Our ref: PS/24079

PROPOSED DEVELOPMENT: 2024/5731/P

Demolition of existing dwellinghouse and erection of three storey replacement house, including excavation of basement. Associated works including replacement of front boundary wall and erection of cycle and waste storage.

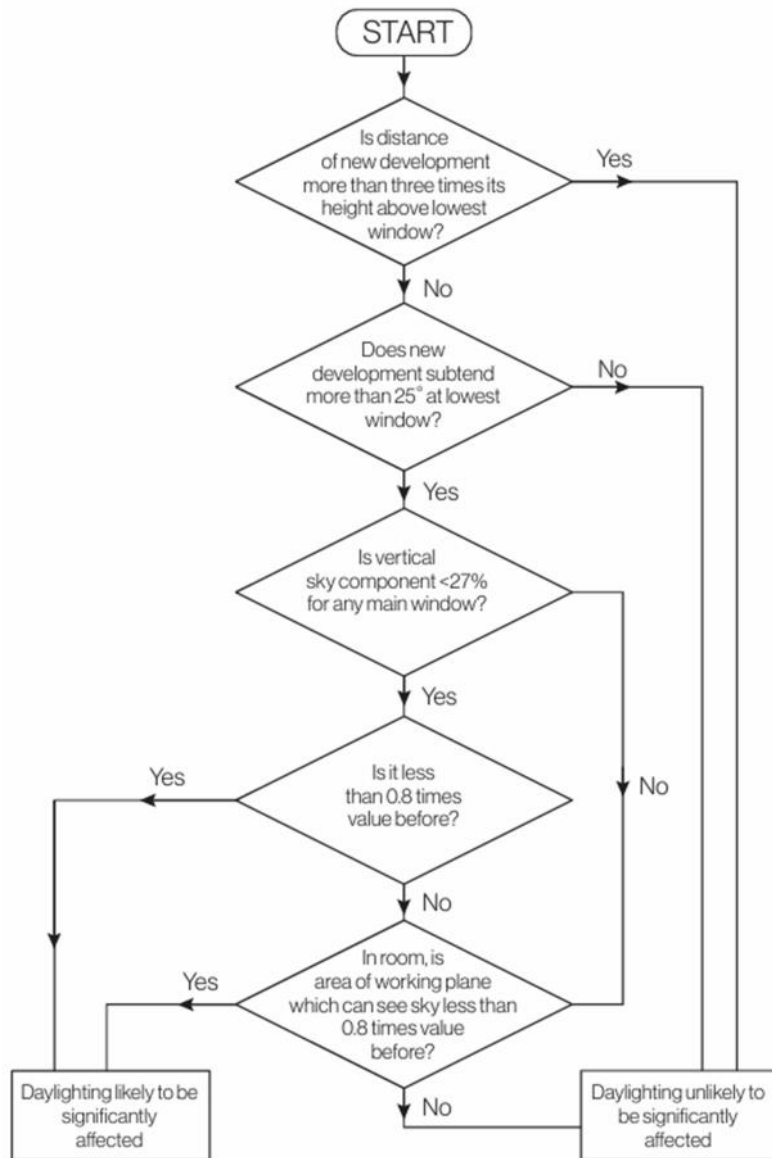
The correct interpretation of this direction within the BRE guide is that, for a room to pass the target standard, it must first pass the VSC requirement and then pass the Distribution of Daylight analysis. If a window does not pass the VSC, the Distribution of Daylight test should not be carried out; the window/room fails the BRE guide standard and the guide states that, as a consequence, the daylight in the room is “likely to be significantly affected”. This is summarised at the sequential table which, below, has been copied from the BRE guide:

Within the BRE Daylight and Sunlight Report for the proposed development, the tests for VSC and DD (Daylight Distribution) have been assessed independently and reported separately, including numbers/percentages of passes and fails. This is misleading and incorrect according to the BRE guide as described above. Again, a room with a window which fails the VSC test has failed; it cannot then be regarded to have passed the DD analysis.

We consider that the representation of the DD results separately in this way is incorrect. As a consequence, we are concerned that this may be misleading to the planning officer and planning committee and we consider that clarification is required.
